Georgia Power

NRC DOCKETS 50-321, 50-366
OPERATING LICENSES DPR-57, NPF-5
EDWIN I. HATCH NUCLEAR PLANT UNITS 1, 2
COMMENTS ON NRC DRAFT APPENDIX I TECHNICAL SPECIFICATIONS

The attached mark-up of sections of the draft NUREG-0473 contains the specific comments as they would apply to Plant Hatch. Application of the specifications would, of course, vary from plant site to plant site, depending on the specific needs of each. Comments on the remaining sections will be provided as our review continues. Should you have questions concerning any of the comments attached, we will be pleased to work with you in this area.

Figure 6.2.1-1
OFFSITE ORGANIZATION

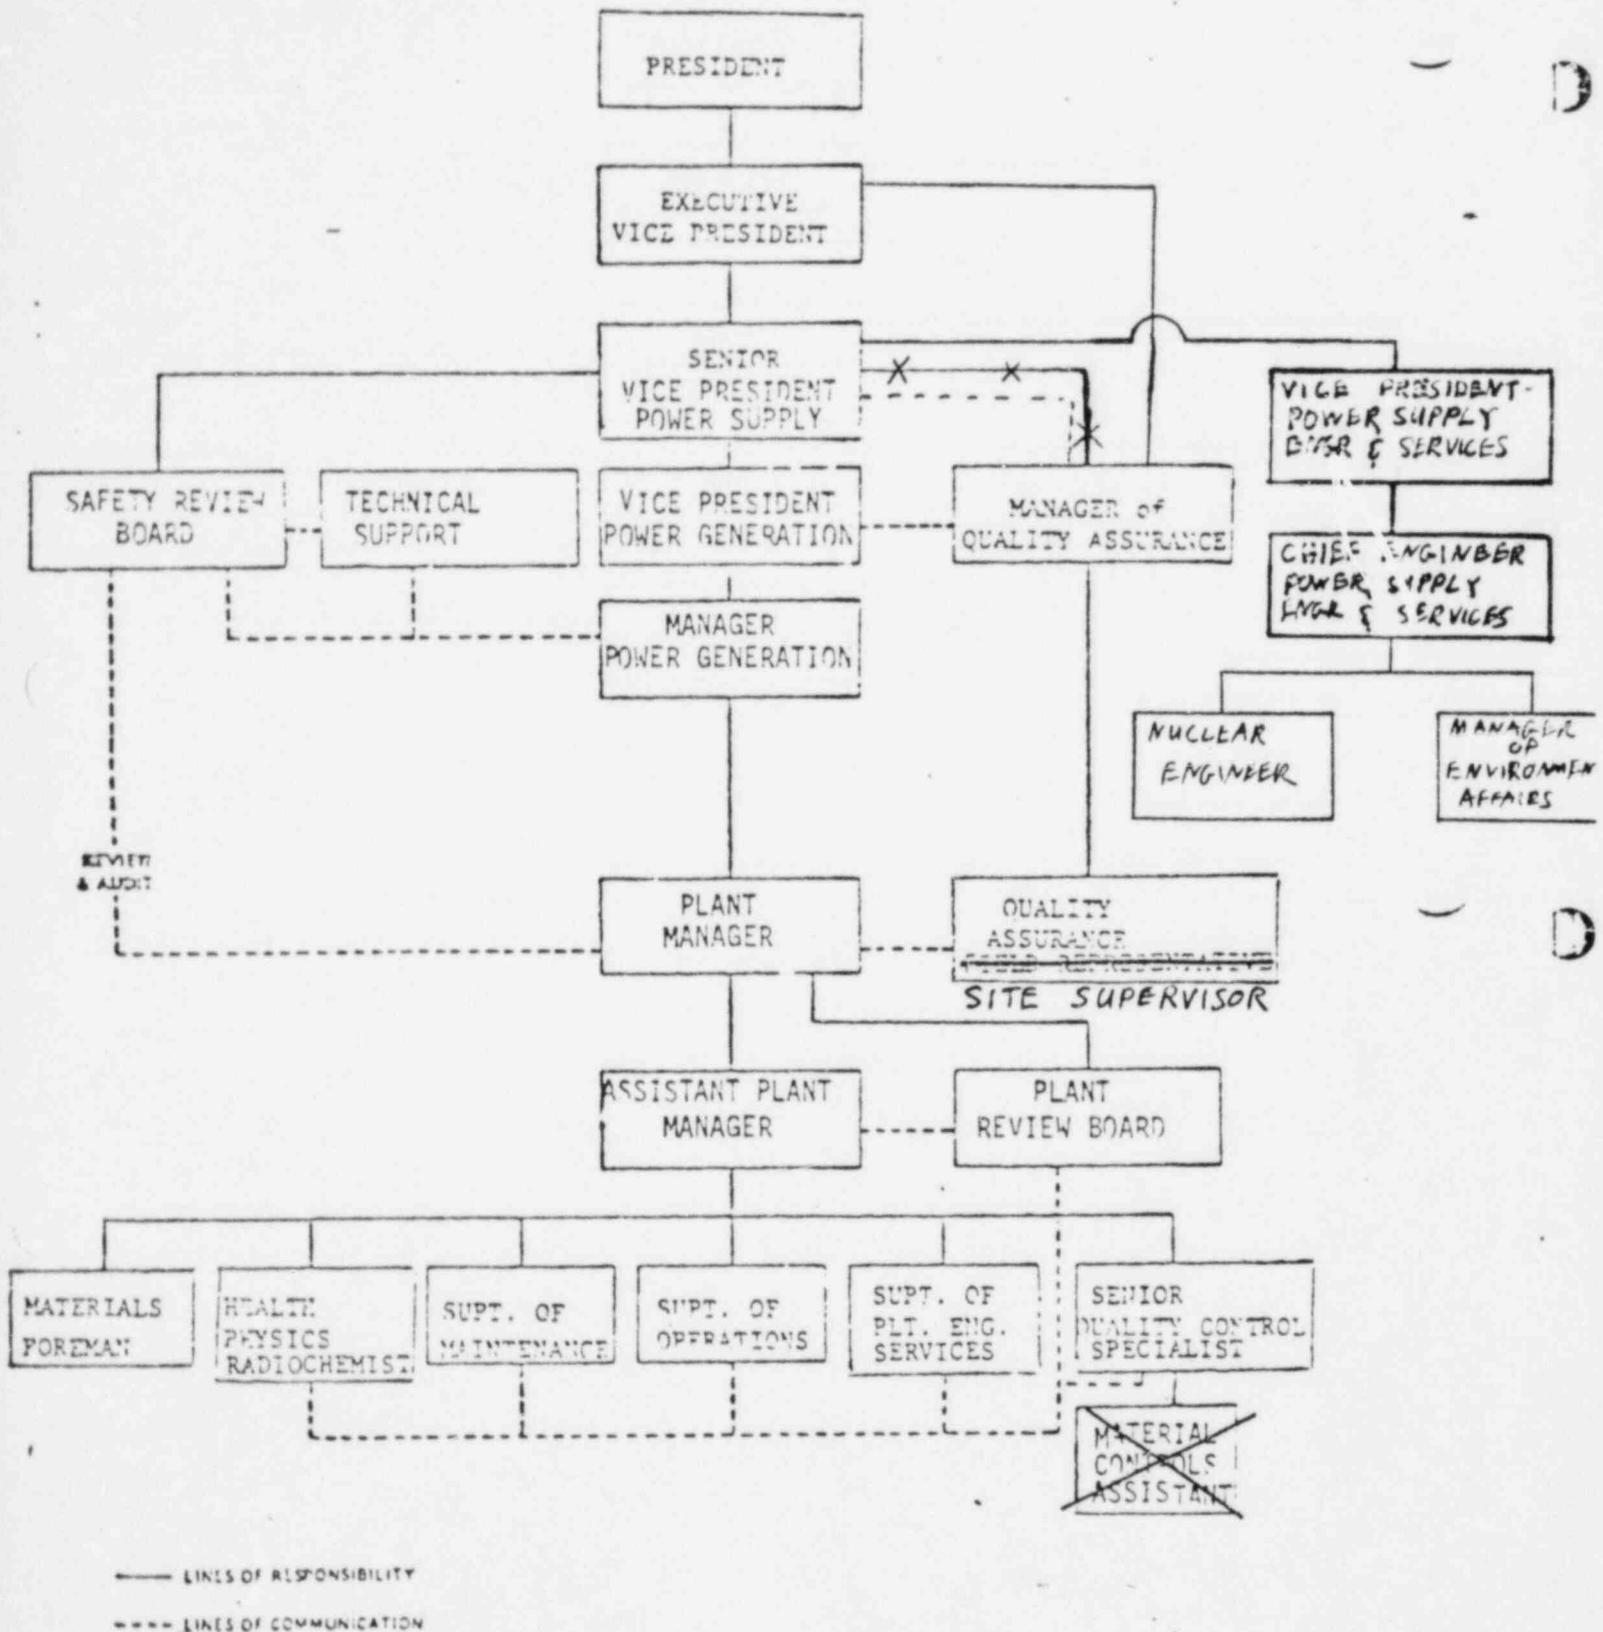
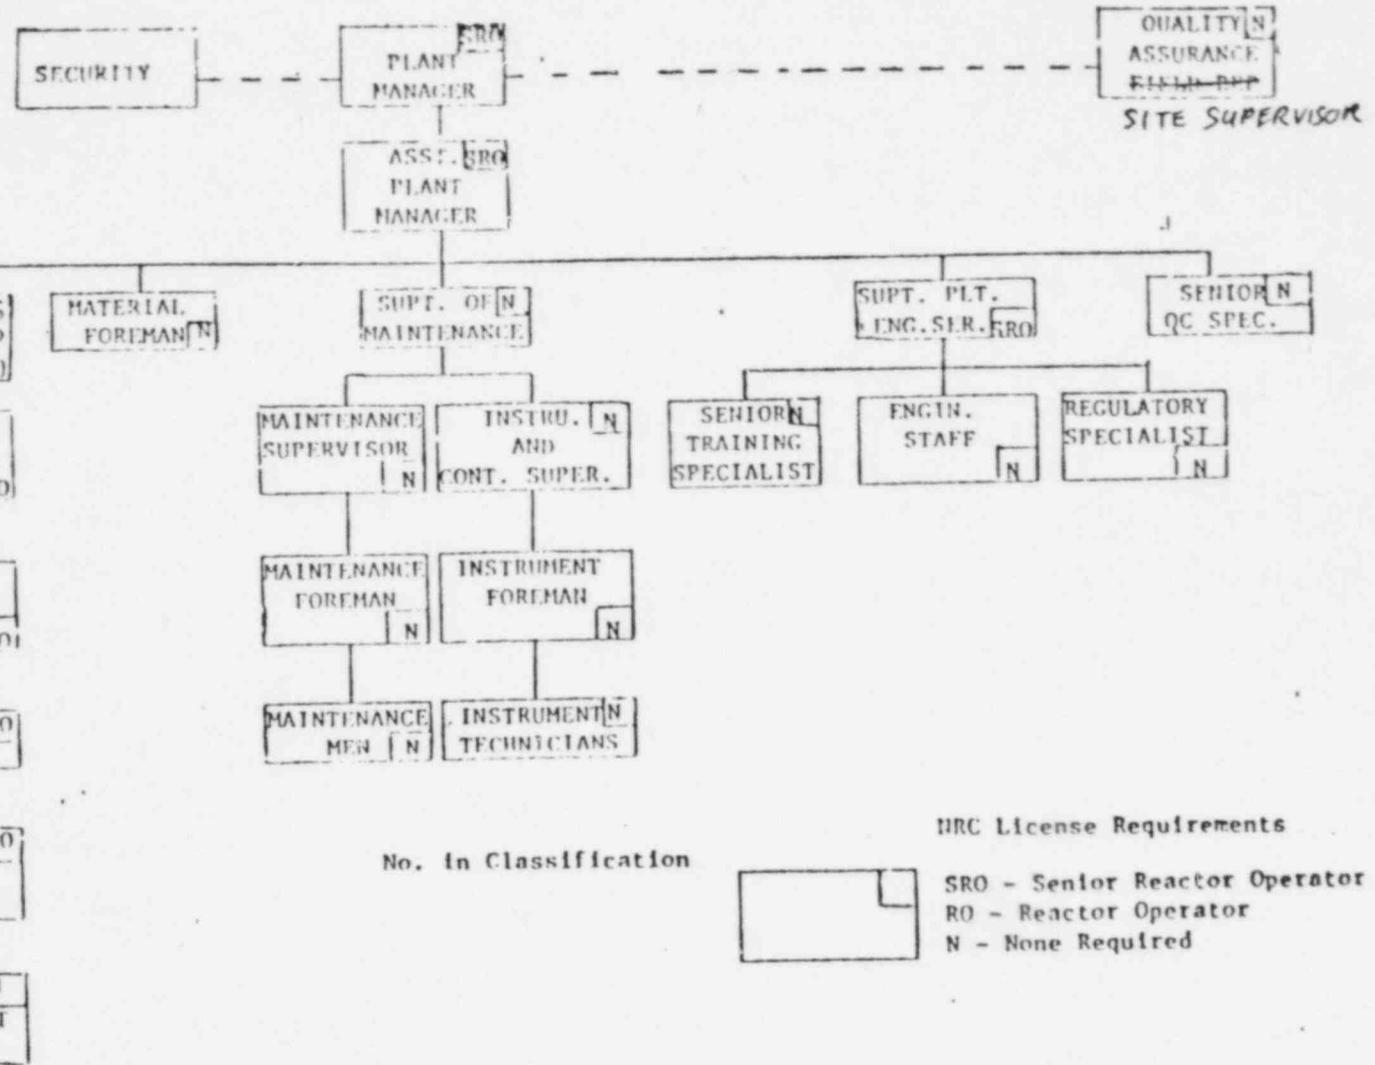
6.2.1 The offsite organization for unit management and technical support shall be as shown on Figure ~~6.2-1~~ 6.2.1-1.
